**MO 152 & N. Platte Purchase Drive
Rezoning**

**MO 152 & N. Platte Purchase Drive
Development Plan (Residential) + Preliminary Plat**

Case No. CD-CPC-2022-00028 & CD-CPC-2022-00029

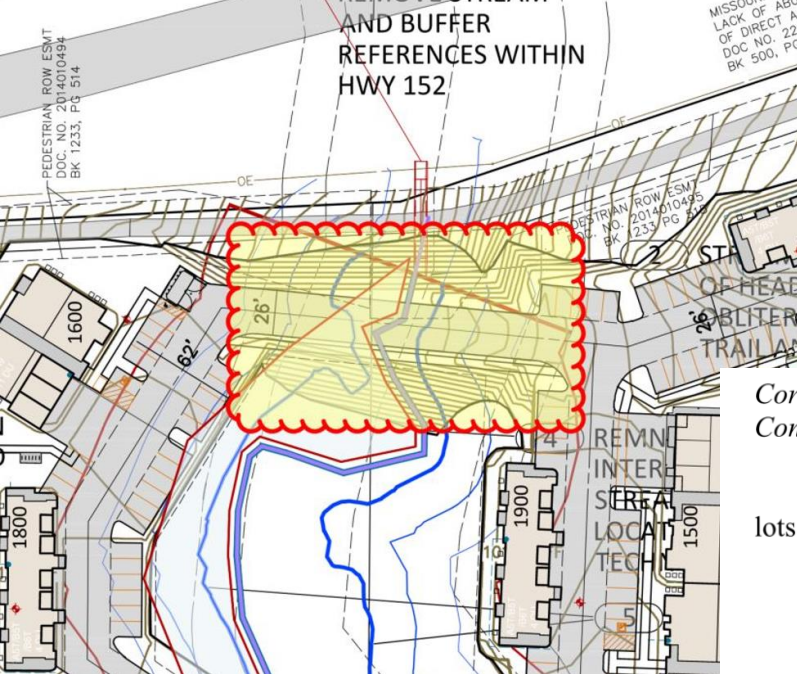
Corrections that were removed after first round of reviews:

1. 25' no build zone
2. Damming not allowed

1. The first 25' of the stream buffer outer zone is no build. Verify that the parking lots on the west side of the stream are outside of the 25' no build zone. (3/18/2022)

2. Damming of the creek is not an allowed method for detention. (3/18/2022)

9. The northern vehicular crossing at the stream shall be approved by KC Water prior to any site disturbance permit being issued. (4/19/2022)

Conditions – Detention is not allowed in stream side or middle zones of stream buffer.

40. The developer must provide documentation to KC Water, sealed by a registered engineer in the state of Missouri, showing that any stormwater detention facilities proposed within streamside or middle zone of stream buffer meet the requirements outlined in Ordinance Number 220322, Section 88-415-05-A.2., and will not induce flooding on properties not owned by developer or must obtain an exception from council per 88-415-08-B, prior to final council approval of the Development Plan.

***Applicant's Response:* Acknowledged. Applicant would like to discuss this further with staff. The stream and buffers were removed at the north end of the site by the construction of the Highway 152 improvements and the construction of the bicycle and pedestrian trail along the south side of Highway 152. The stream and buffers were removed at the south of the site at the time of construction of Northwest 87th Terrace and Barry School. The map that is contained in the Stream Buffer Ordinance is incorrect and it should be corrected to reflect this. Stream threads through the area have been replaced by storm drains. The extent of the existing stream remnant was determined by field surveys in preparation of obtaining an Approved Jurisdictional Determination from the Corps of Engineers. The extent of the existing riparian buffer remnant was delineated by Terra Foundation.**

***Applicant's Response:* See response to No. 1 above.**
